Forsyth County Procurement

ADDENDUM #6

RFP 20-78-1620

For: Providing all labor, equipment and materials for the construction of a new Juvenile Justice Center at 875 Lanier 400 Parkway, Cumming, GA 30040. Project includes a multi-phased site development, demolition of existing motel structures and construction of new 62,000 square foot Juvenile Court building.

Sheet No.
A-7.61

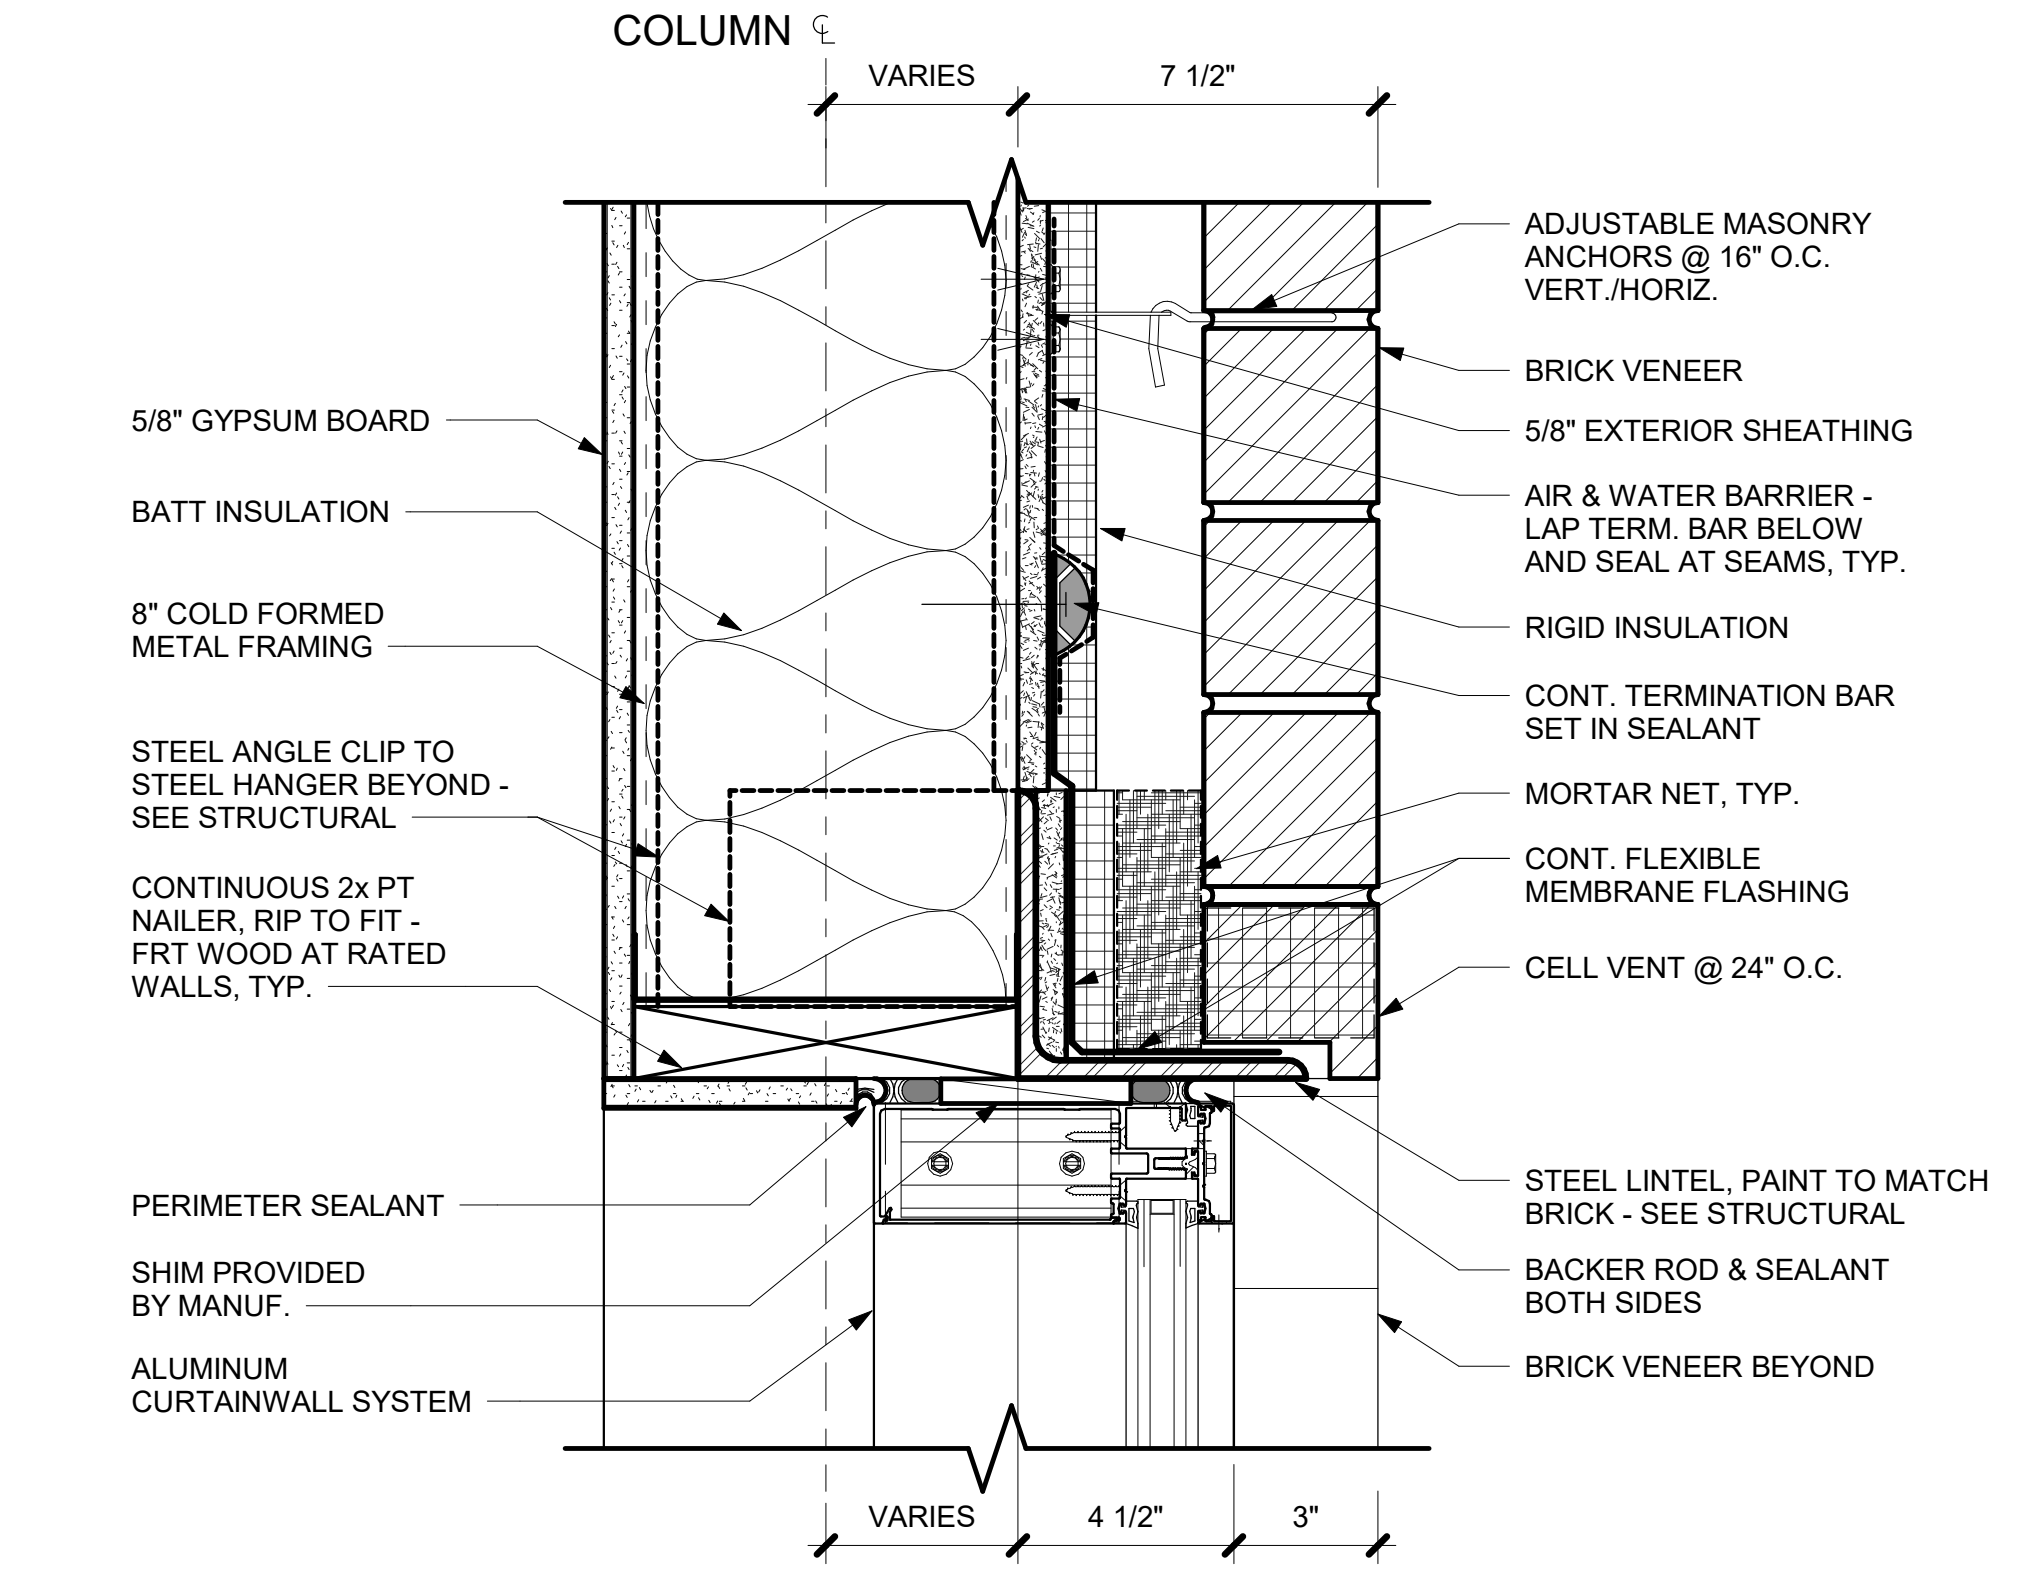
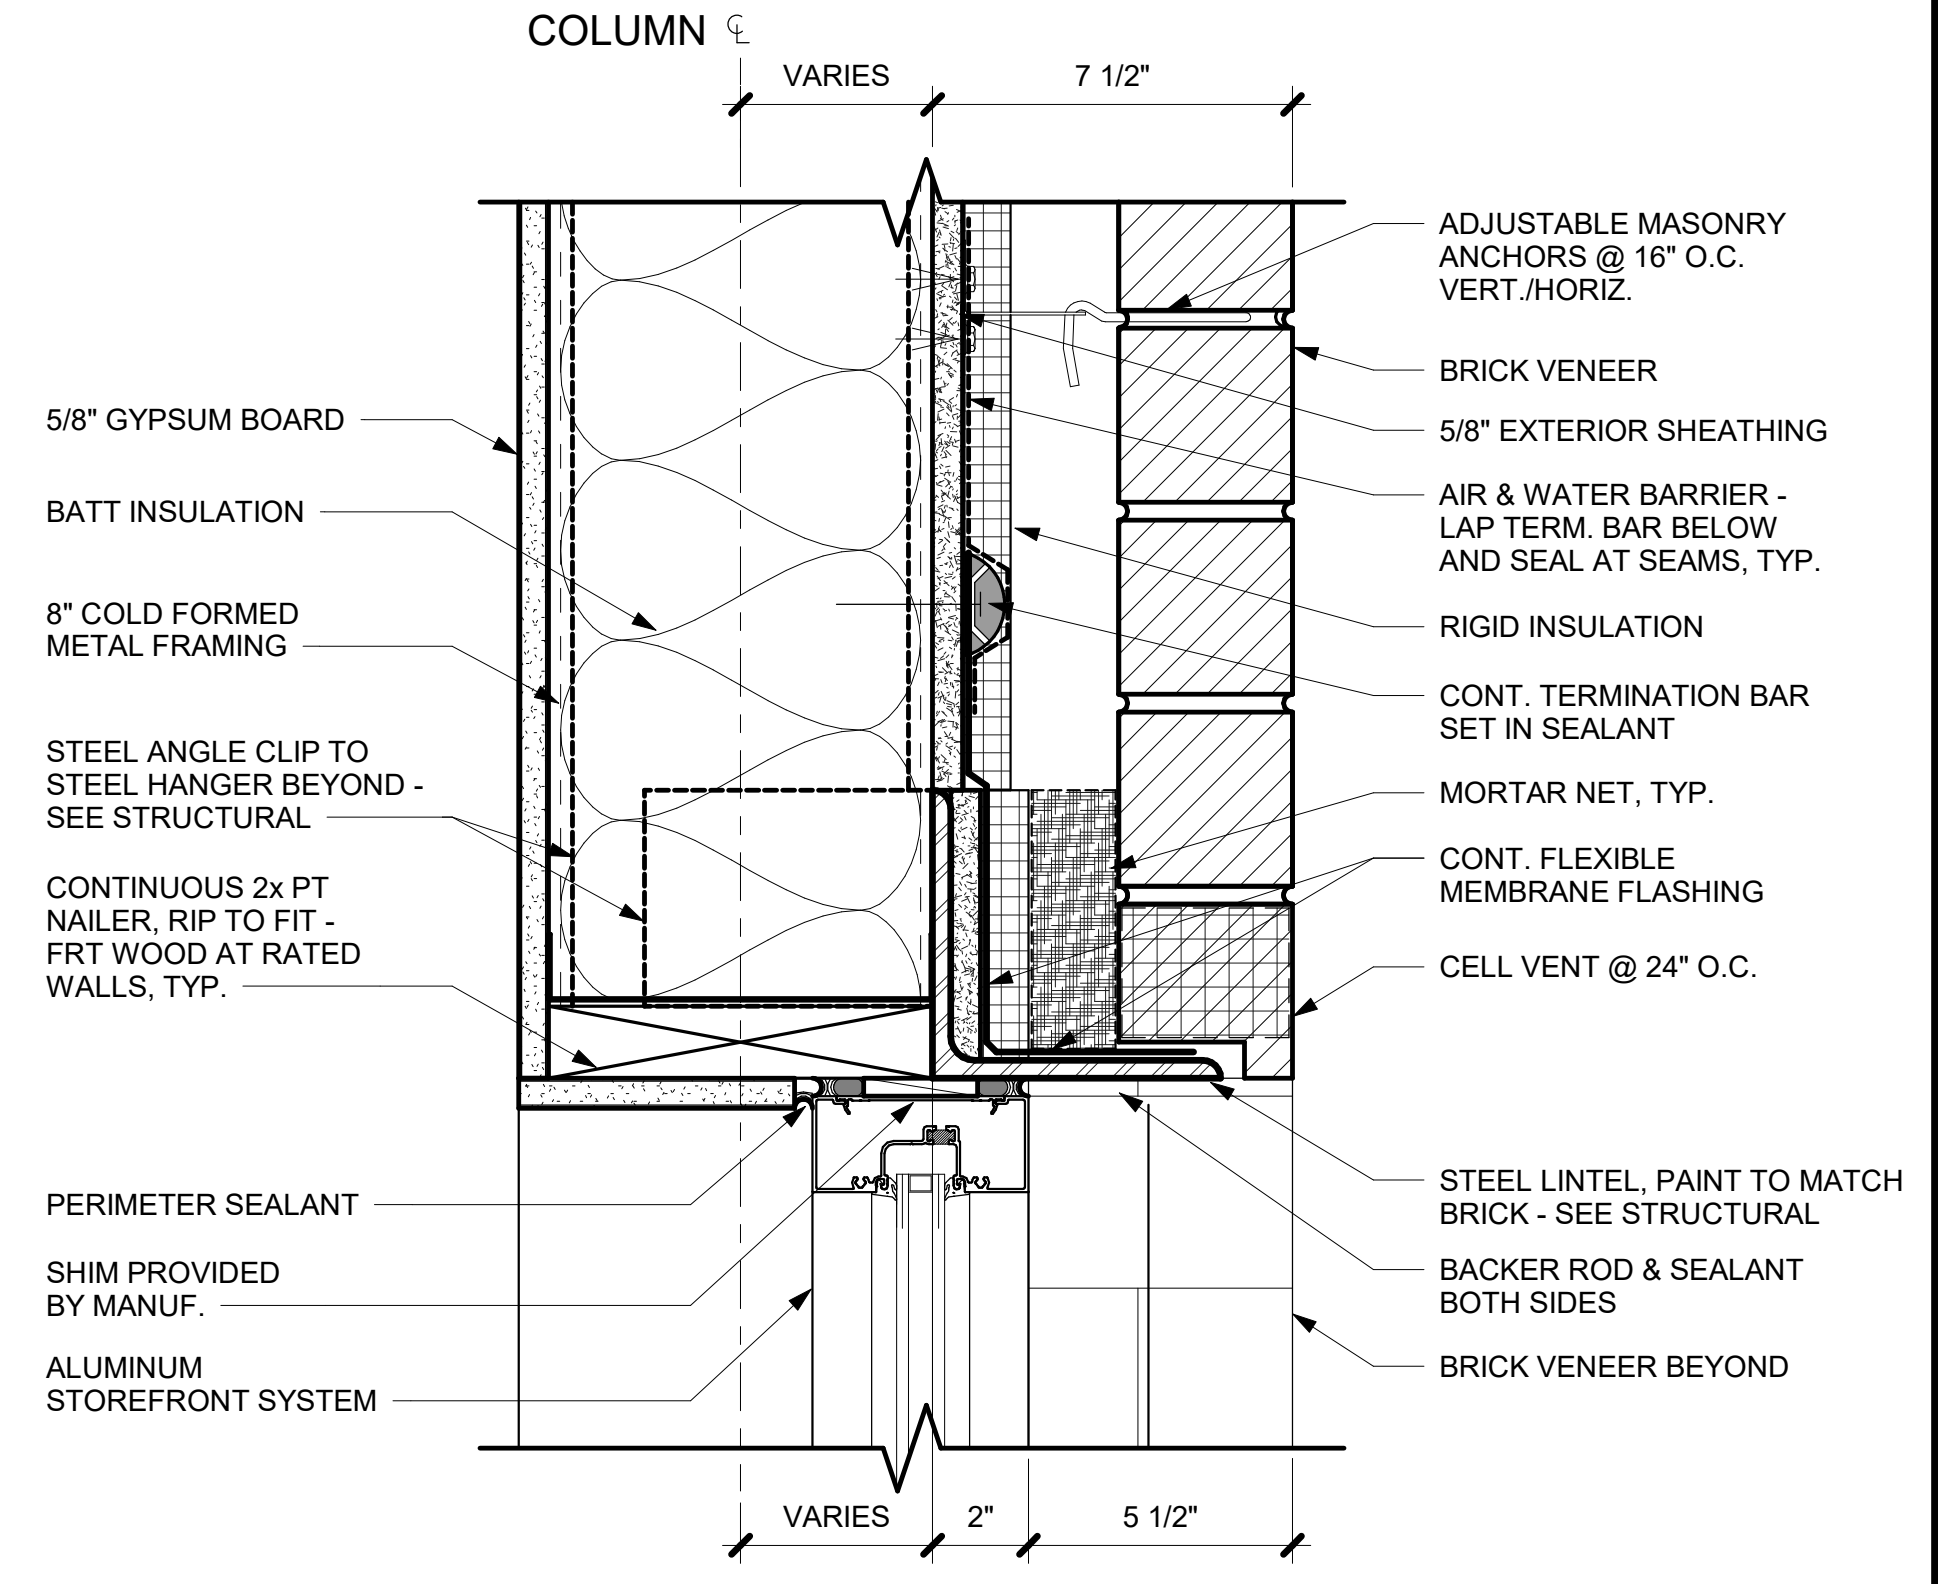
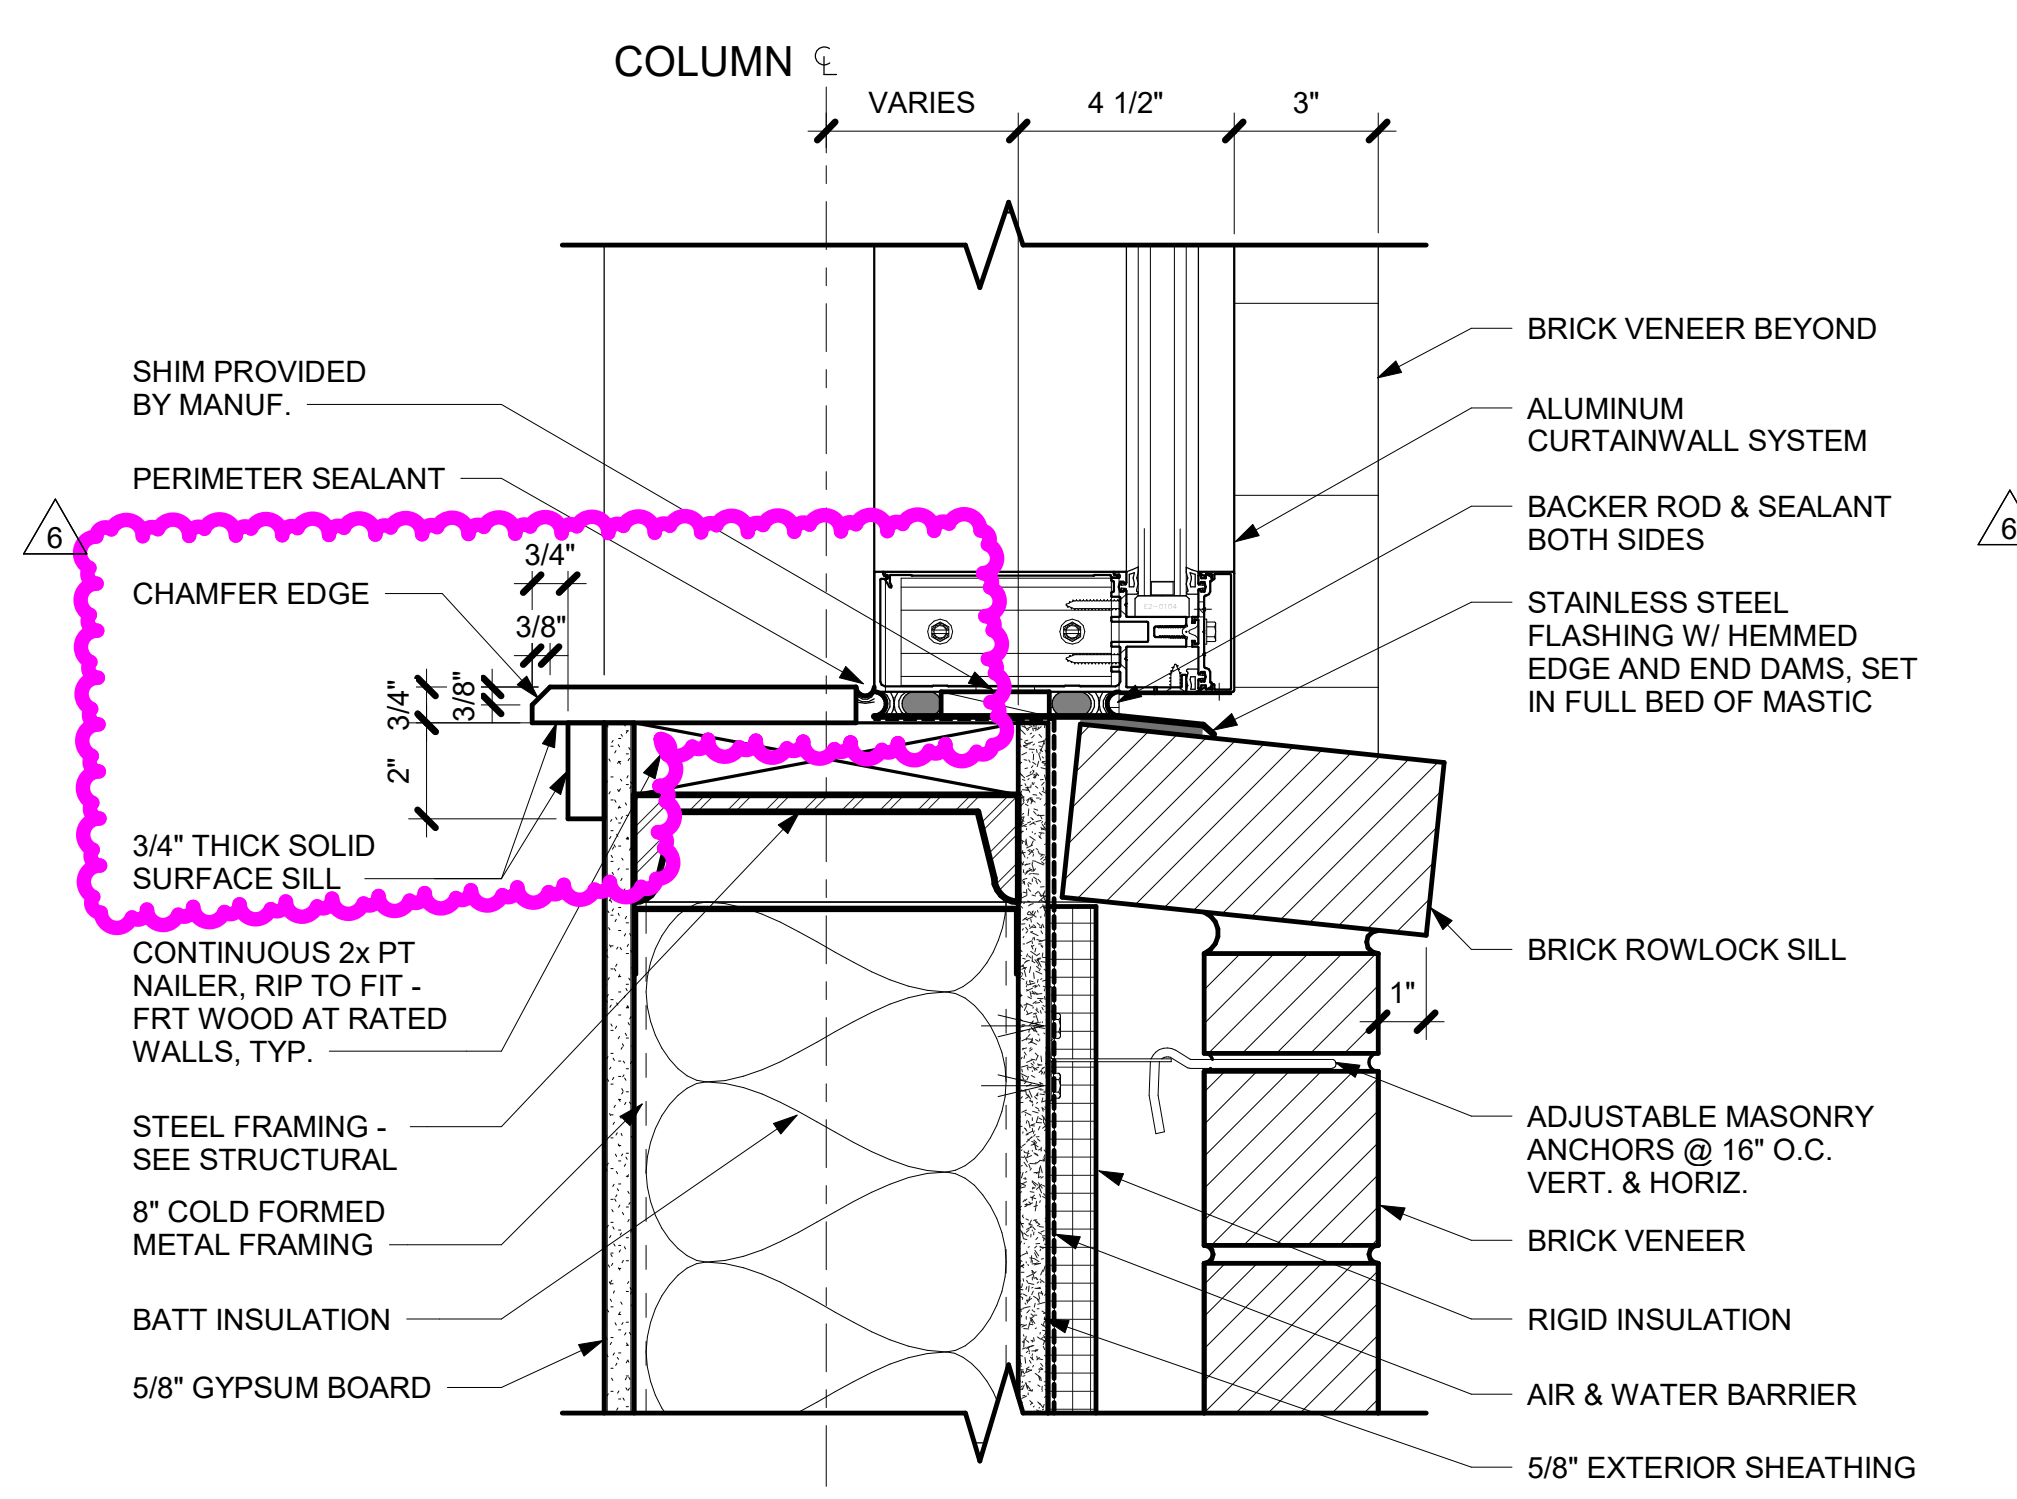
- 2-10 Sheet A-7.61 WINDOW DETAILS:
1. Revised sill details to show trim.
